**APPLICATION FOR PERMISSION
UNDER SECTION 16 OF
THE TOWN PLANNING ORDINANCE
(CAP. 131)**

For Official Use Only 請勿填寫此欄	Application No. 申請編號	A/TL-LFS/554
	Date Received 收到日期	2025-03-26

(a) Proposed use(s)/development 擬議用途/發展	擬議臨時貨倉存放汽車零件及建築材料 (Please illustrate the details of the proposal on a layout plan) (請用平面圖說明擬議詳情)
(b) Effective period of permission applied for 申請的許可有效期	<input checked="" type="checkbox"/> year(s) 年 3 _____ <input type="checkbox"/> month(s) 個月 _____

PROJECT : PROPOSED TEMPORARY WAREHOUSE FOR STORAGE OF VEHICLE PARTS AND CONSTRUCTION MATERIALS FOR A PERIOD OF 3 YEARS LOTS 1962, 1963 (PART), 1979 S.A, 1979 RP, 1980, 1981 AND 1982 IN D.D. 129, LAU FAU SHAN, YUEN LONG, NEW TERRITORIES	DRAWING TITLE : F.S. Notes, Legend, Fire Service Installation Layout Plan	ARCHITECT :	CONSULTANT :	FIRE SERVICE CONTRACTOR : Century Fire Service Engineering Co., Ltd.	DRAWING NO : FS-01	REV. 0
REV	DESCRIPTION	DATE

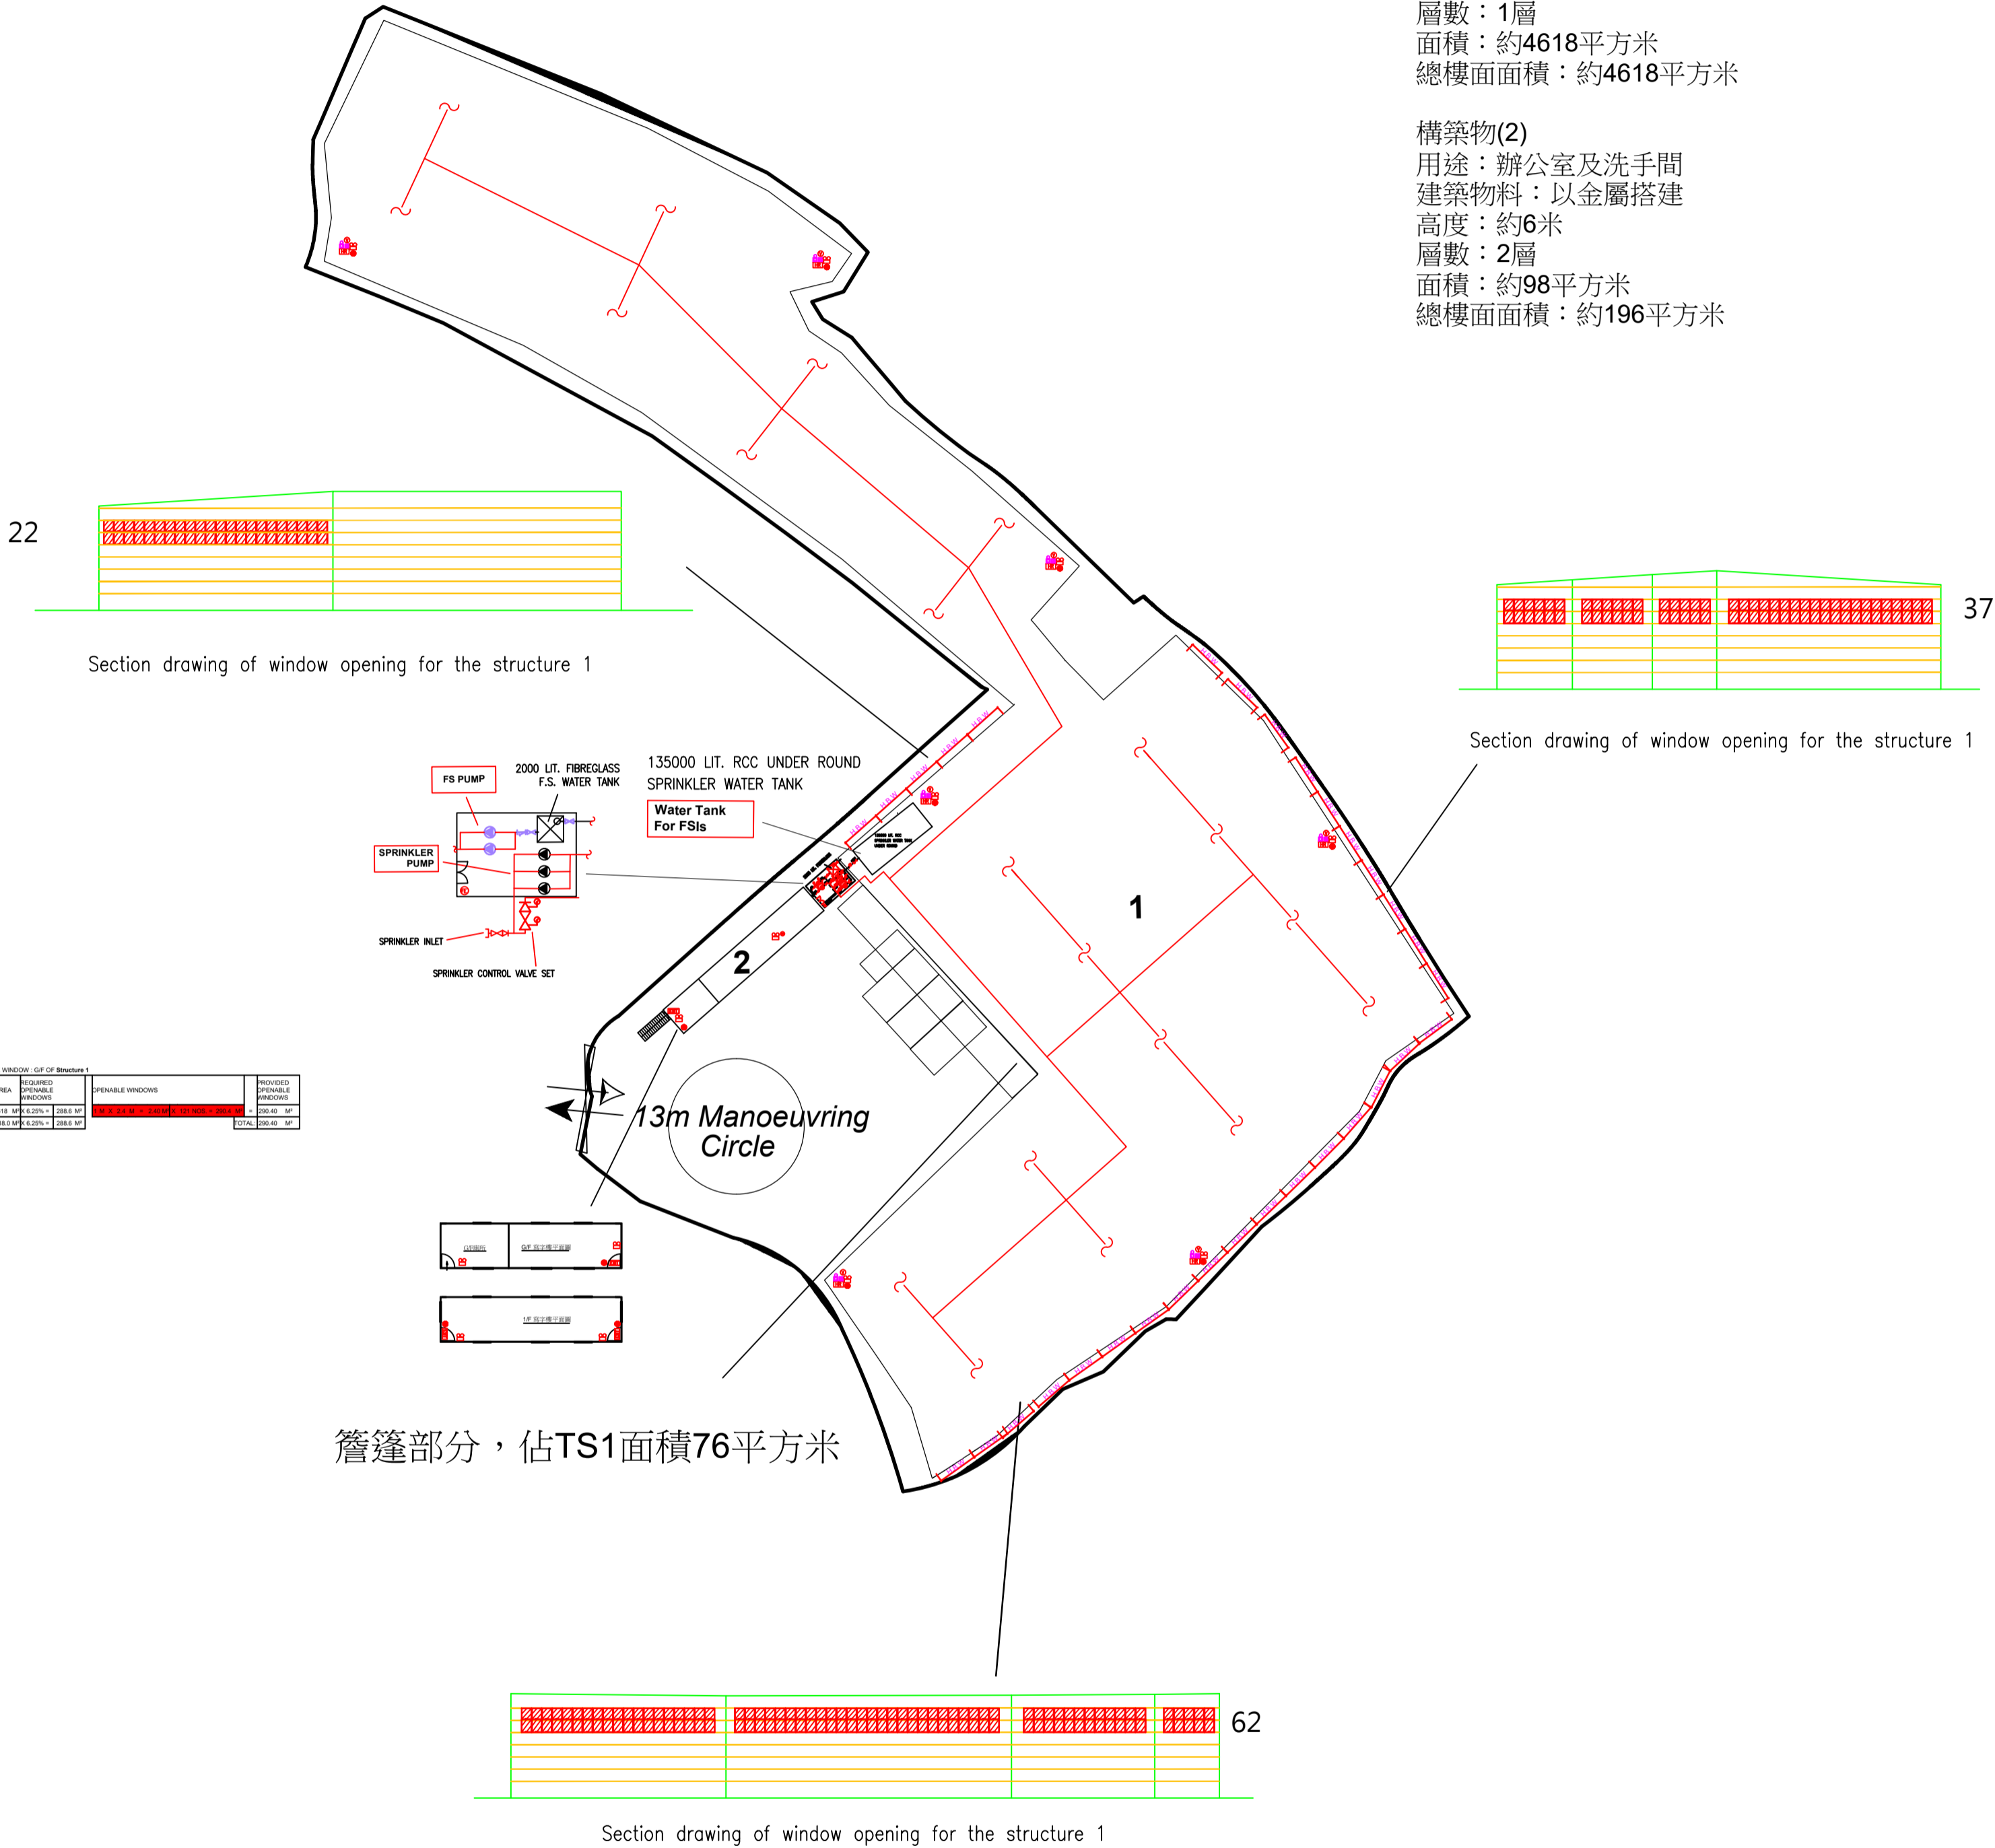
- (i) calculation of openable windows shall be clearly demonstrated on plans to justify FS Notes item 1.6;
 - (ii) sprinkler system, wheeled type dry chemical fire extinguisher, stand-alone fire detector, emergency lighting and directional and exit sign shall be provided for enclosed structures with total floor area exceeding 230m²;

- (vii) the sprinkler inlet shall be positioned in a prominent position and preferably near the entrance of the Site;
 - (viii) modified hose reel system and fire alarm system are considered as self-upgrade and not a mandatory requirement by his Department;

園境設計圖

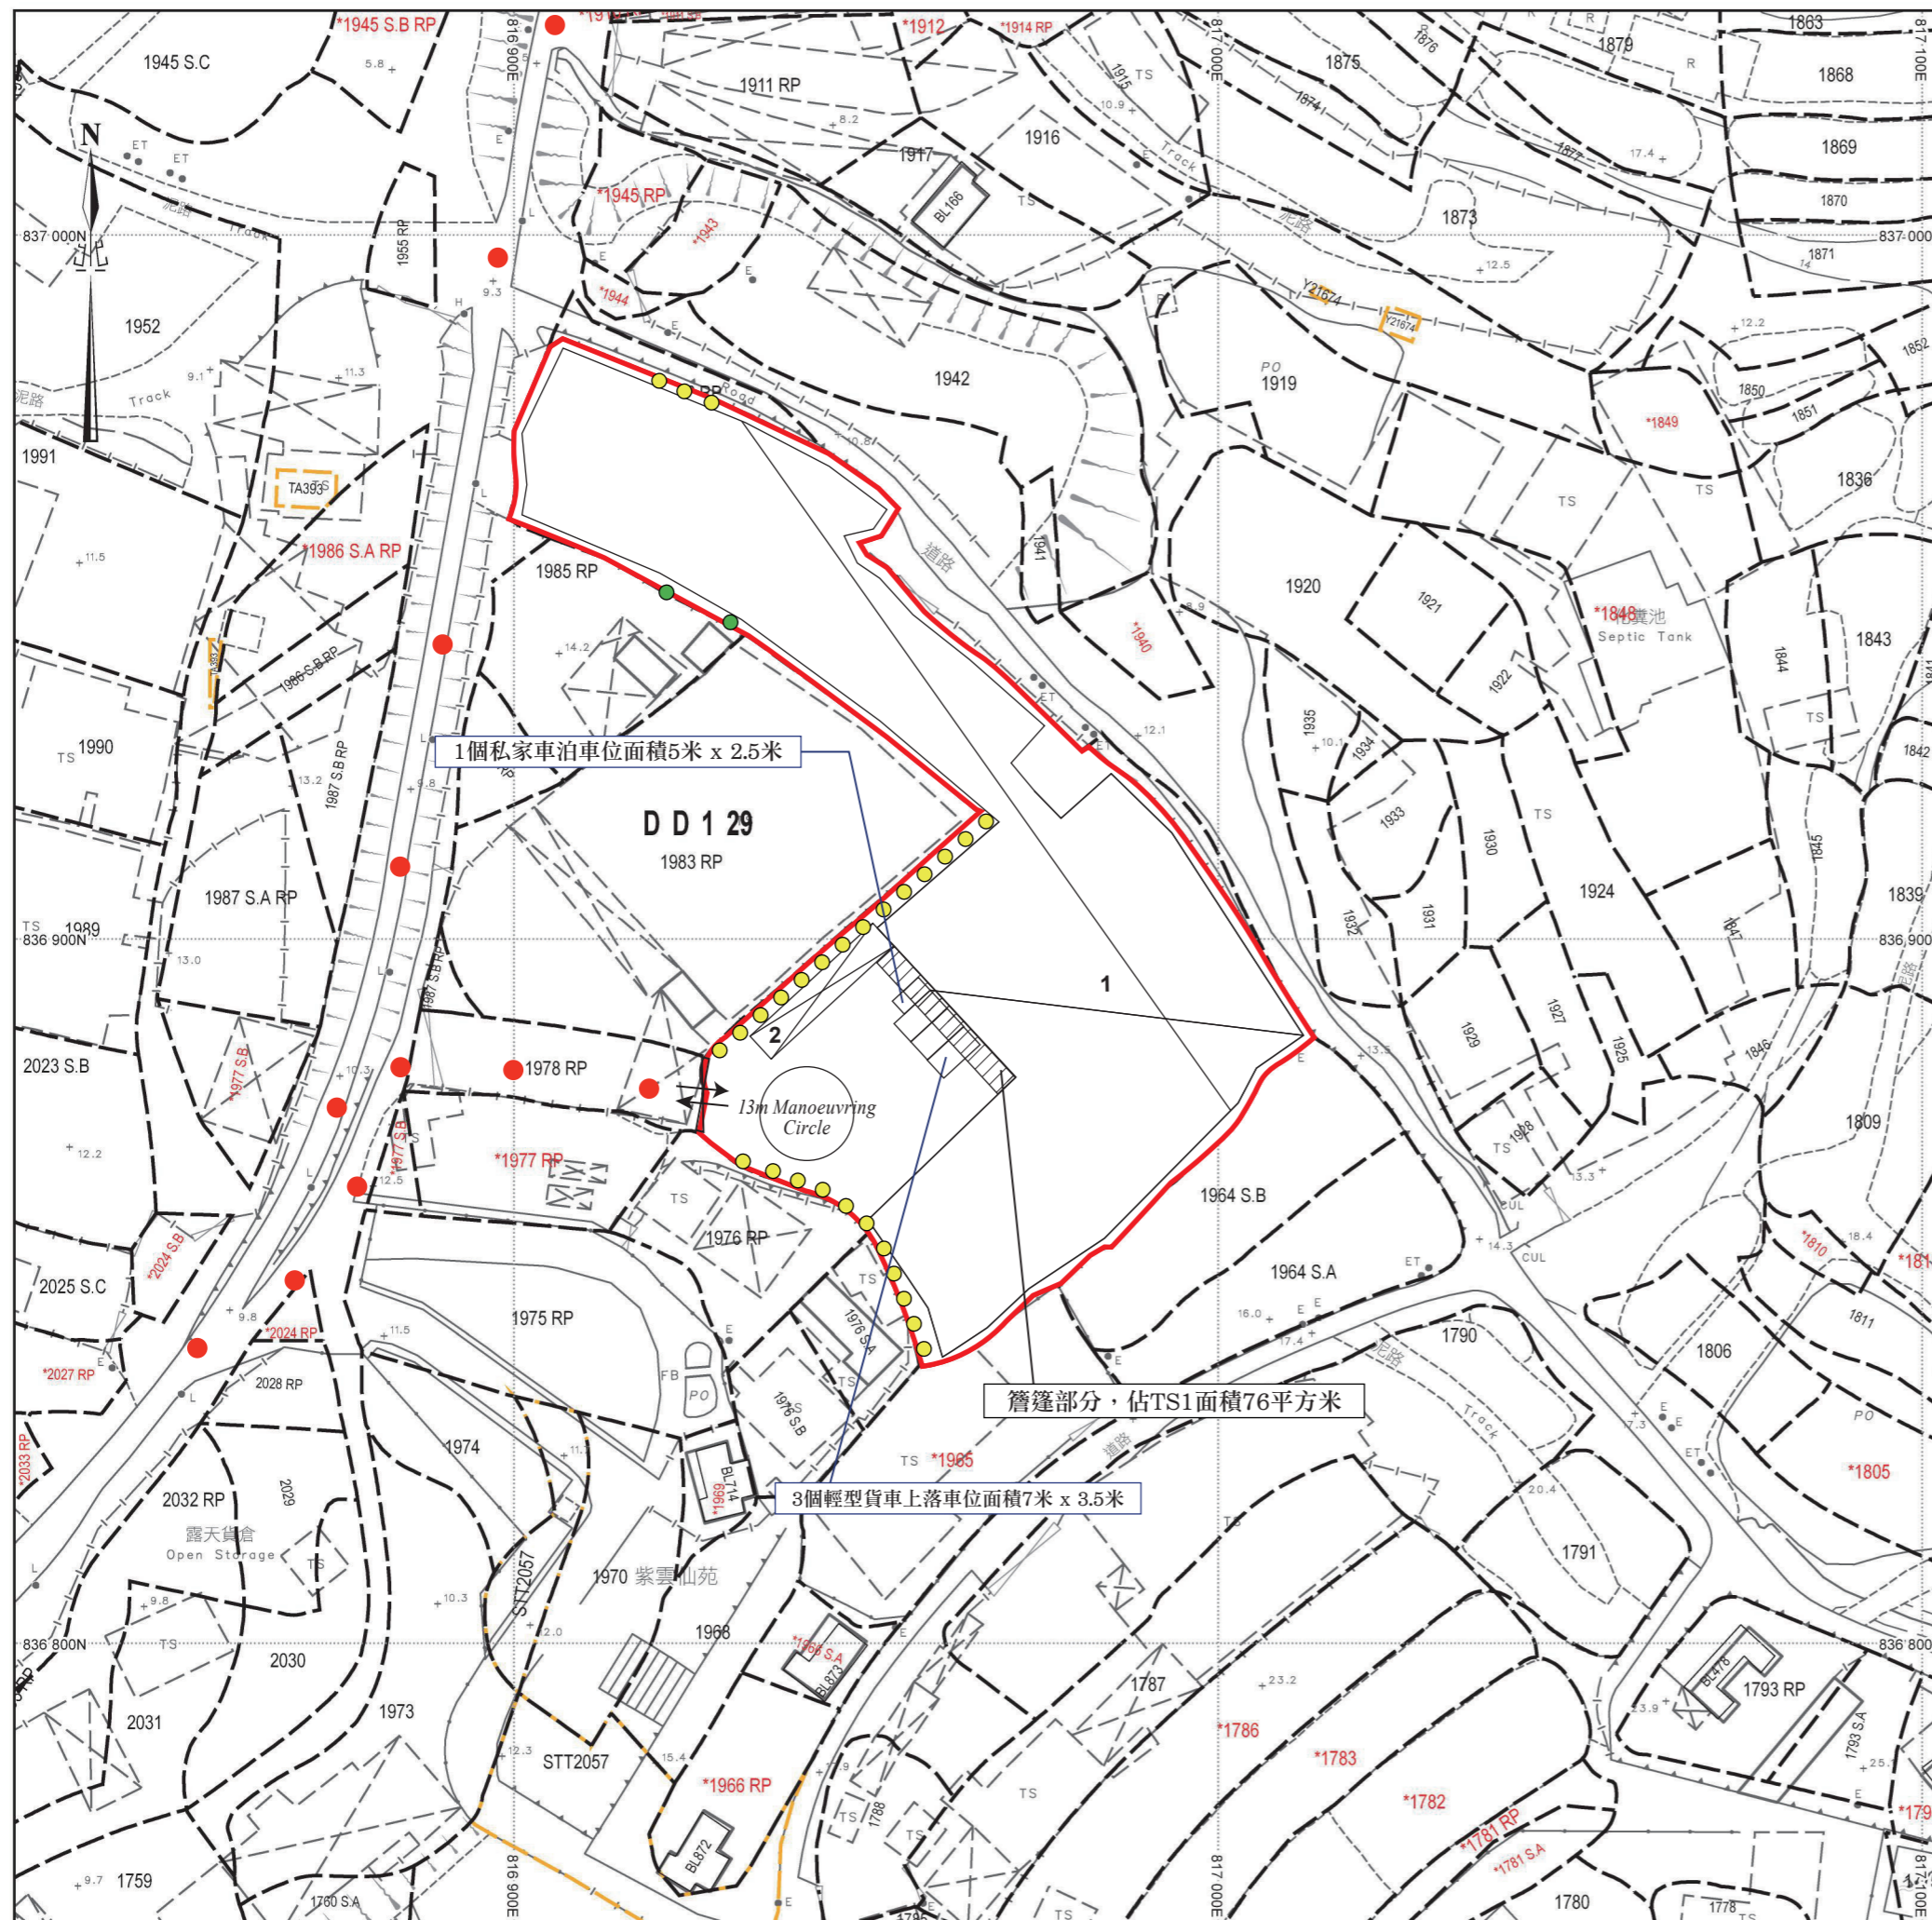
- (b) According to the submitted “園境設計圖” (**Drawing A-4**), there are 28 *Senna surattensis* (黃槐) and two *Ficus microcarpa* (細葉榕) along the boundary of the Site and there will be no conflict between the existing trees and the proposed structure. It is stated in the application form that no tree felling and no landscape impact would be caused by the applied use. She therefore has no adverse comment from landscape planning perspective since no significant adverse landscape impact arising from the applied use is anticipated.

有關園境設計圖，場內有 30 棵現有樹木，分別是 28 棵黃槐及 2 棵細葉榕(可參閱附件)。現有樹木與構築物 1 並沒有衝突，因樹木是存在於構築物旁邊，分別存在於場地南面、西南面及北面，因此搭建時並不會牽涉到伐木。申請人承諾會保育及保護一共 30 棵現有樹木。
